CHUCK DAVIS FAMILY SUBDIVISION

APPLICATION NUMBER	4	DATE	June 16, 2022
APPLICANT	Chuck Davis Family Subdivision		
REQUEST	Subdivision

SITE PLAN

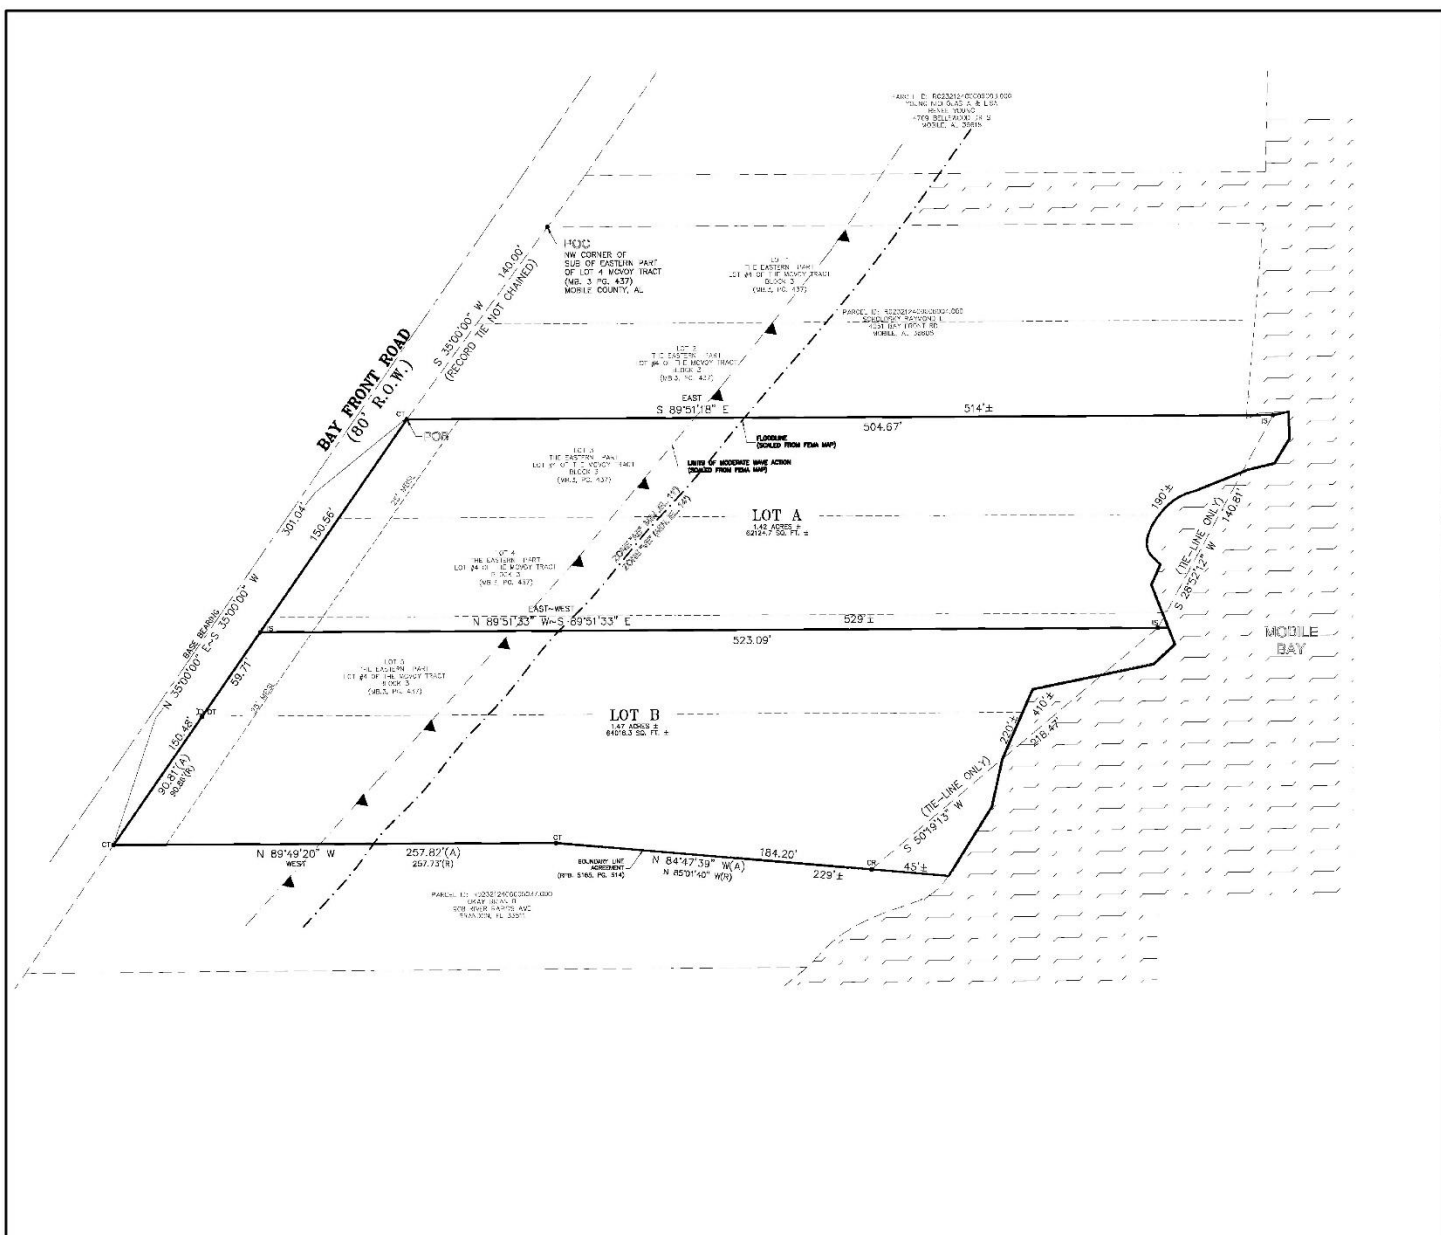
- A. Remove the County Engineer's signature block from the plat. The County Engineer no longer signs plats within the municipal limits of the City of Mobile.

- B. Remove the Mobile County Engineering Department note. This proposed subdivision is located within the city limits. The County Engineering Dept. no longer reviews/comments on subdivision plats within the municipal limits of the City of Mobile.

- C. Provide all of the required information on the SUBDIVISION PLAT (i.e. signature blocks, signatures, certification statements, written legal description, required notes, legend, scale, bearings and distances) that is required by the current Alabama State Board of Licensure for Professional Engineers and Land Surveyors.

- D. Provide a note that a 25' riparian buffer may be required, during development, along the edge of anything considered by ADEM to be a water of the state.

- E. Show and label the BFE (Base Flood Elevation) on each lot that contains an AE, V, or X (shaded) flood zone designation.
- F. Add a signature block for the Planning Commission, Traffic Engineer, and City Engineer.

- G. Add a note to the SUBDIVISION PLAT stating that as shown on the 1984 aerial photo LOTS A and B will receive historical credit of existing (1984) impervious area towards stormwater detention requirement per Mobile City Code, Chapter 17, Storm Water Management and Flood Control) as follows: LOT A – 2,800 sf and LOT 2 –NONE.

The site has frontage on Bay Front Road, a minor street without curb and gutter, and a required 60-foot right-of-way. The preliminary plat illustrates right-of-way width as 80 feet which, if approved, should be retained on the Final Plat.

The plat indicates a 25-foot minimum building setback line along Bay Front Road, and this should be retained on the Final Plat, if approved.

The proposed lots meet the minimum size requirements of the Subdivision Regulations. As on the preliminary plat, the lot size label in both square feet and acres should be retained on the Final Plat, or a table should be furnished on the Final Plat providing the same information, if approved.

- 1) retention of the right-of-way width label of Bay Front Road on the Final Plat to illustrate the existing right-of-way;
- 2) retention of the 25-foot minimum building setback line along Bay Front Road on the Final Plat;

- 3) retention of the lot size label in both square feet and acres on the Final Plat, or the furnishing of a table on the Final Plat providing the same information;
